9 March 2011

15 February 2011

[REDACTED] Basement Water Inundation

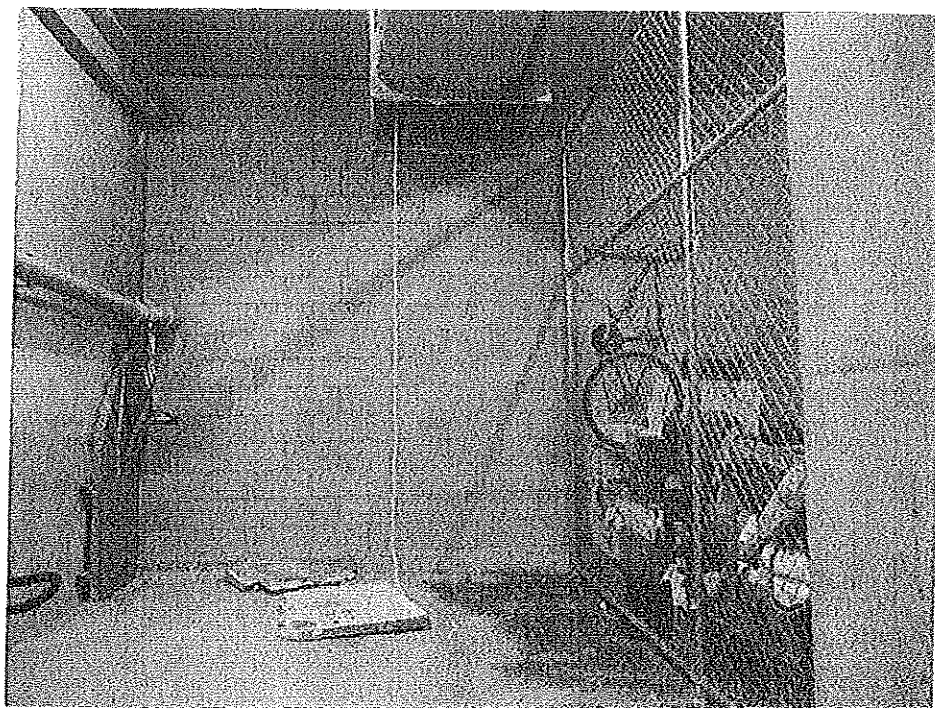
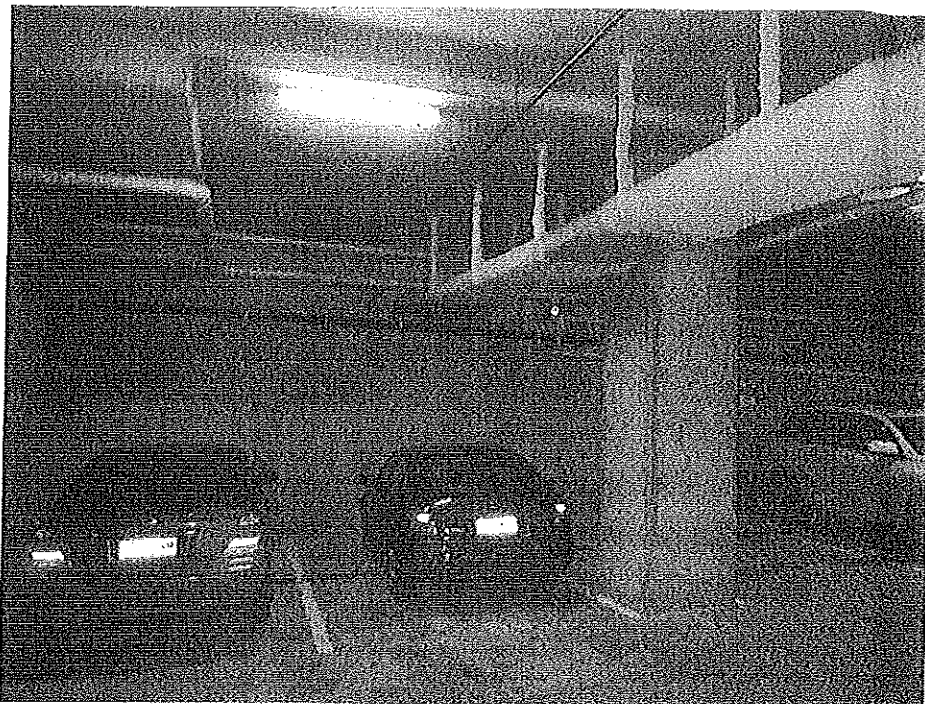
The source of the water inundation is believed to be at the incoming electricity mains to the building on the [REDACTED] Street Frontage. Marked up drawings are attached and photographs follow for identification of this primary water inundation source. A "waterfall" from this location was observed by staff on site during the event. The water staining on the vermiculite encasing of the incoming conduits and failed fire proofing of the entry location boxing soffit also confirm the likelihood of this location being the main source of water entry into the basement.

GROUND LEVEL FLOOR PLAN

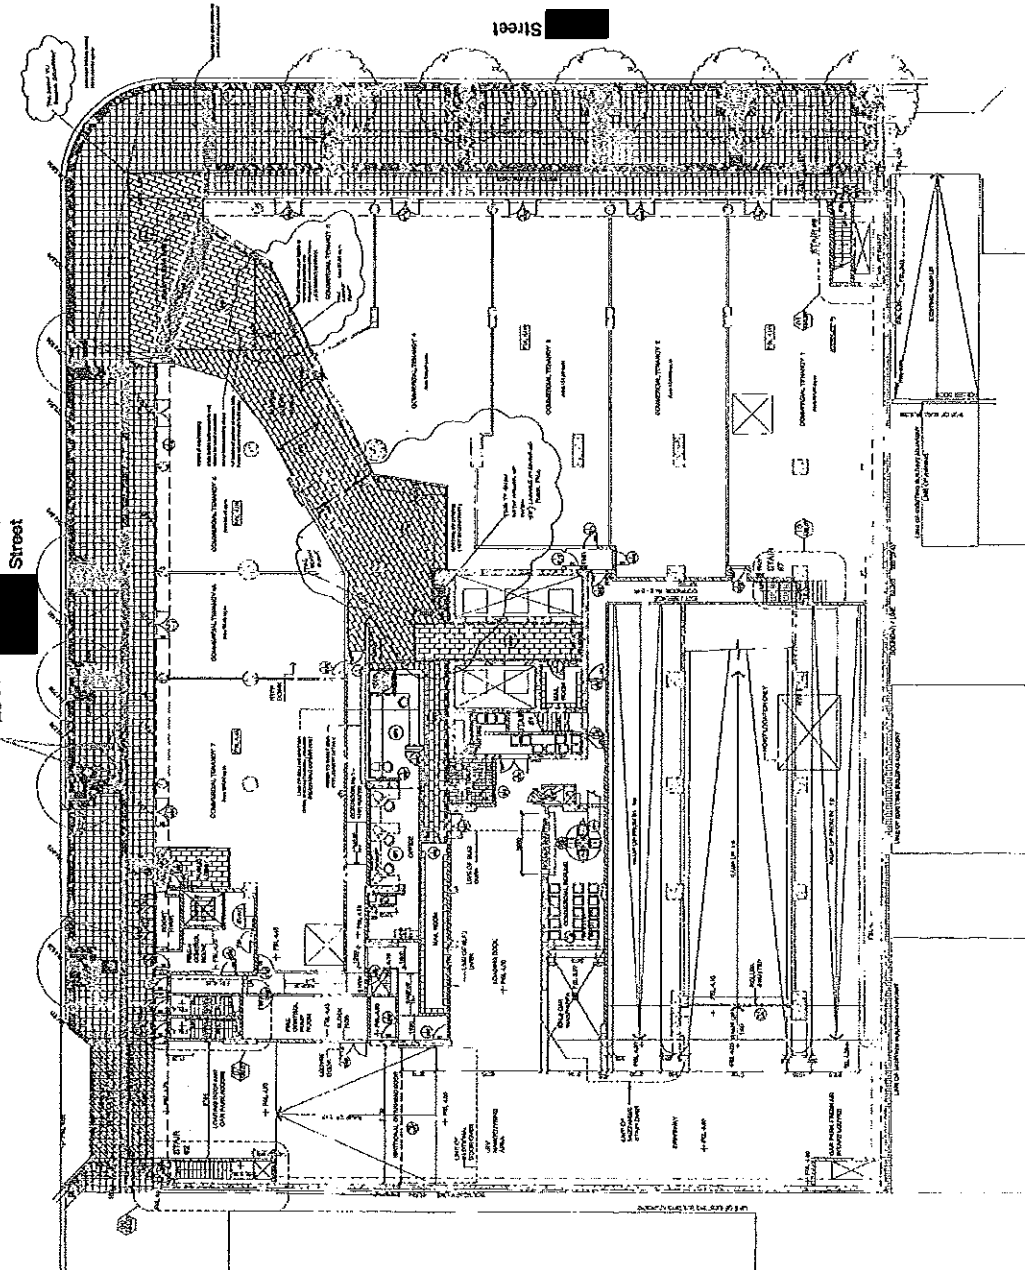
LOCATION OF ELEVATOR PITS IN STREET.
